TECHNICAL SERVICE BULLETIN reissue No. JTB00021v4/2007 30 July 2007

Subject/Concern:	Phone Call Quality Poor to Third-Party
Model:	
The New XK	VIN Range: B00379-B20074
Markets:	All
Section:	419-08 - Cellular Phone
Summary	
<p>The third-party caller cannot hear speech very well while the car is being driven. There is a lot of background noise that interferes with the sound quality.</p> <p>Version 4 of this bulletin has been issued due to a change in Action, Parts Required, Labor Time and the Service Instruction.</p> <p>Cause: This is a combination of microphone positioning and noise cancellation/signal processing within the phone system software.</p> <p>Action: Should a customer express concern, install a new external microphone and depending on VIN, re-configure the Bluetooth Telephone Module using Integrated Diagnostic System (IDS). Follow the Service Instruction outlined below.</p>

E96543

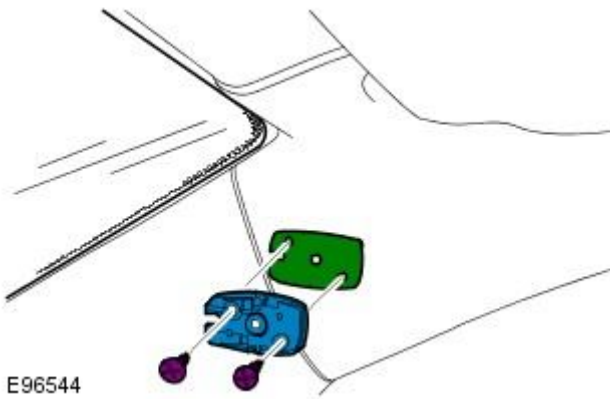
2. Locate the plate centrally in the area shown in E96543 so the front of the plate is next to the seam line but not overlapping the 'A' pillar.

3. Whilst holding the mounting plate in position, mark the countersunk holes onto upper trim (see E96543).

E96544

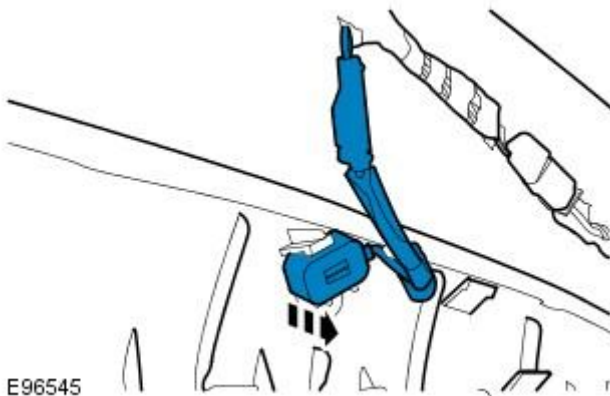
5. **One metal plate in the microphone kit is not used.**

Place one metal backing plate between the trim panel and the mounting plate and fix into position using the two self tapping screws provided.

E96545

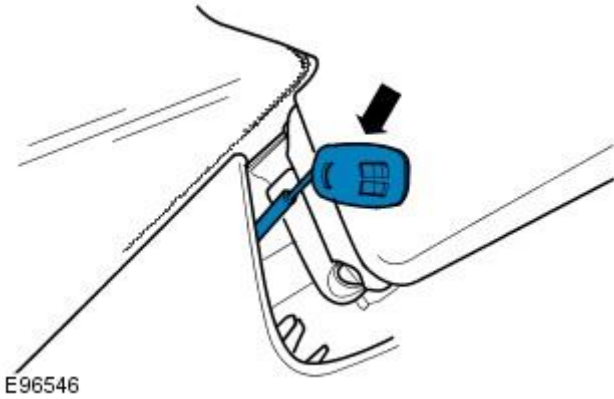
Pull back 'A' pillar trim and remove internal microphone from trim and disconnect from harness.

7. Clip external mouse microphone to mounting plate and connect to the vehicle harness.
